Re: Toxic Substances Control Act, Polychlorinated Biphenyls (PCBs) – PCB Cleanup, Former Pechiney Cast Plate Facility, Vernon, California – AMEC's Proposed Modifications to USEPA's Approvals

In this letter, USEPA is modifying certain conditions in its PCB cleanup approvals under 40 CFR 761.61(c) dated July 2, 2010 (Approval #1) and July 1, 2011 (Approval #2). The modifications to these approvals are based on the above meeting, AMEC's January 24, 2014 e-mail message (attached)[1], the Approvals. These modifications are been made consistent with the requirements in 40 CFR 761.61(c).

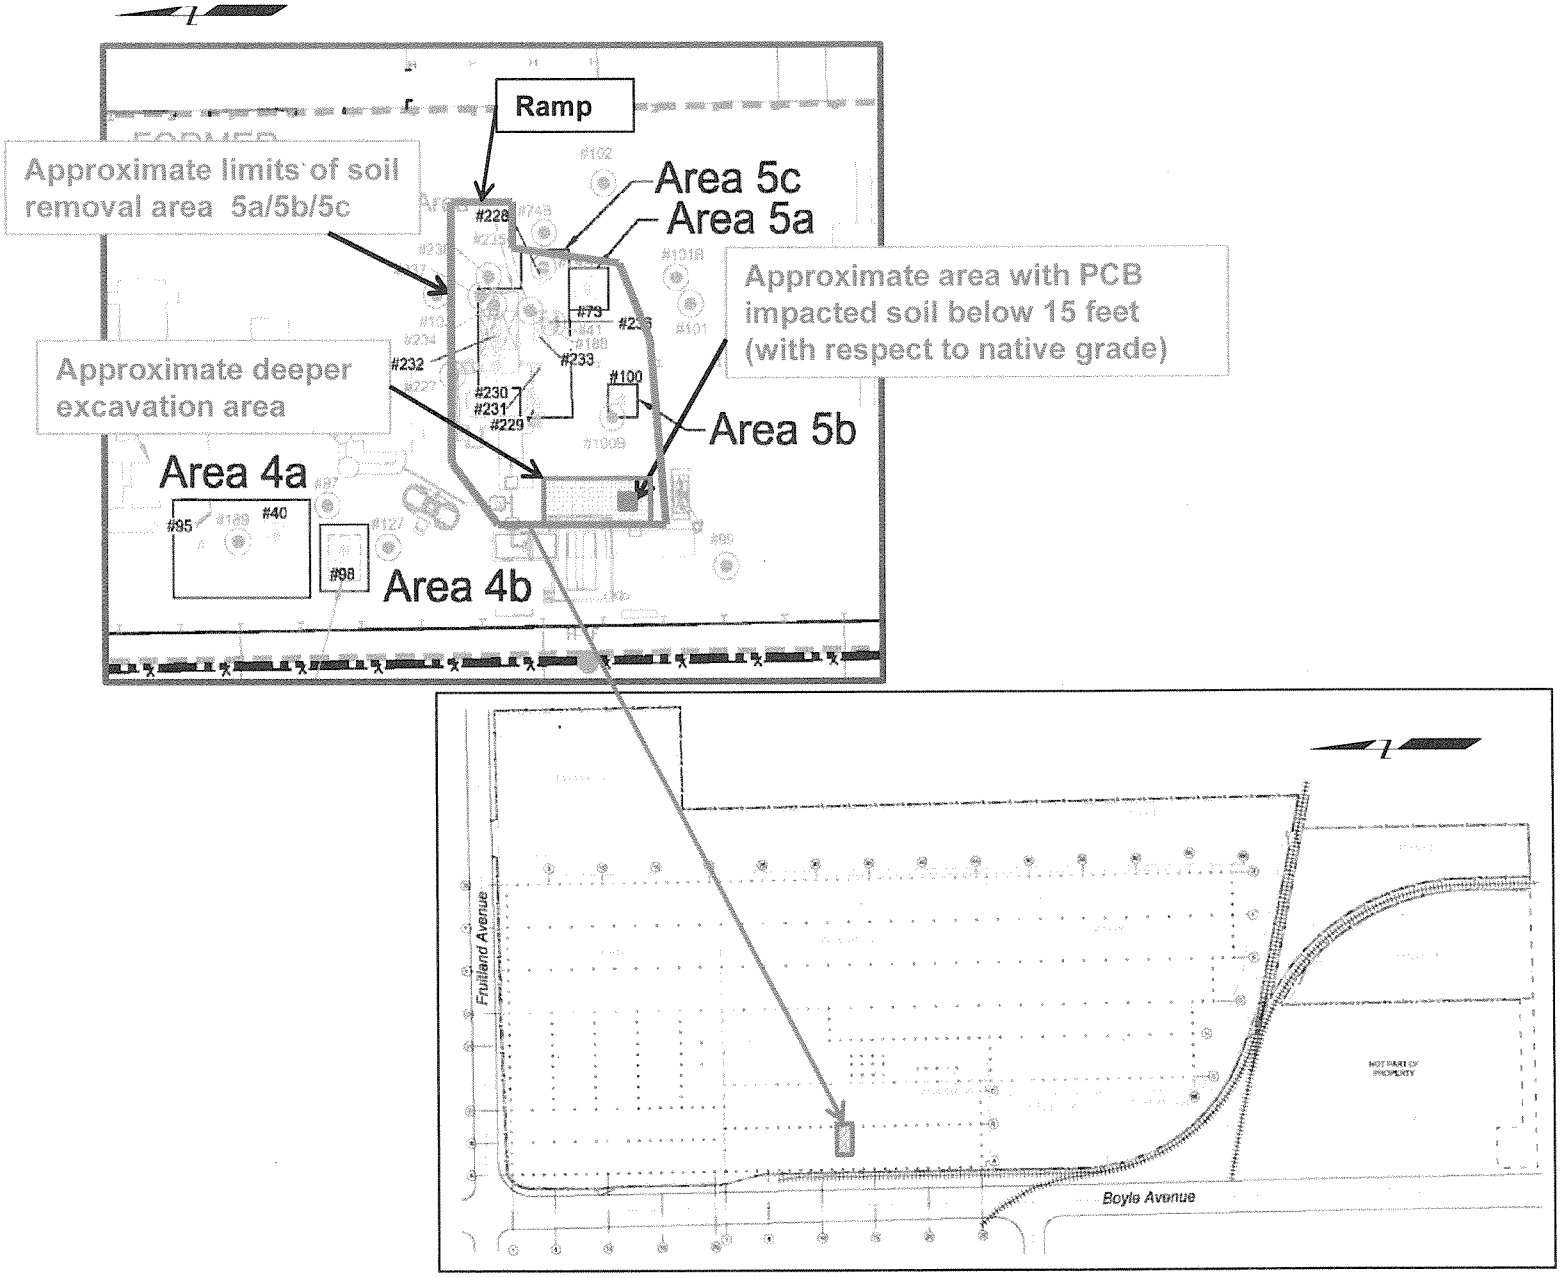
3) **PCB impacted soil at depths below 15 feet.** PCB-impacted soil at depths greater than 15 feet (below native grade) has been encountered in the soil removal area 5a/5b/5c areas (also referred to the Area C in our Application and the 2012 RAP). In this area, the existing concrete slab is about 4 feet above native site grade. The base of the deeper portion of the soil removal area (shown in blue on the attached figure) is currently at about 21 to 30 feet below the slab (or about 17 to 26 feet below native grade) depending on the location on the excavation floor. In the southern portion of the deeper excavation, soil containing PCBs at concentrations exceeding 23 mg/kg (actual measured concentration at this location is 73.6 mg/kg) is proposed to be left in place at an approximate depth of 26 feet below native grade. These site conditions are similar to the site conditions as specified in the Conditional Approval (refer to Section C.3.b.6; July 2, 2010 Conditional Approval letter and site grading plan) for the proposed 4a/4b soil removal area.

The proposed modification to the Approval includes placing a physical barrier consisting of a minimum of 6 inches of concrete or cement slurry over the PCB-impacted soil at depth of greater than 15 feet below native grade. This modification will be applied to any areas where soil containing PCBs at concentrations greater than 23 mg/kg at depths greater than 15 feet below native grade with conditions consistent with the Approval for the proposed 4a/4b soil removal area. At this time, this modification is only expected to be applied to the 5a/5b/5c (Area C) excavation. For Area C, a cement-slurry in lieu of the concrete may be used based on worker safety

USEPA Modification to Approvals #1 and #2. The total PCB and Aroclor 1254 concentration in soils below 15 feet below ground surface (bgs [i.e., below native grade]) must be confirmed via collection and analysis of in-situ, discrete samples during underground demolition, if such data does not exist already. Soils below 15 feet bgs are defined here as Deep Soils.

Alternative: Deep Soils (below 15 feet bgs) exceeding 23 mg/kg total PCBs and/or 2.0 mg/kg Aroclor 1254 (where Aroclor 1254 is the only detected Aroclor) before or after soil excavation and removal, may remain in place if:

(b) A physical underground warning barrier (UWB) that is effective for the long term is installed at the floor of the 5 to 15 feet bgs PCB-remediation interval for soils. The UWB will warn about the presence of Deep Soils beneath the UWB exceeding the cleanup levels for the 5 to 15 feet bgs remediation interval.
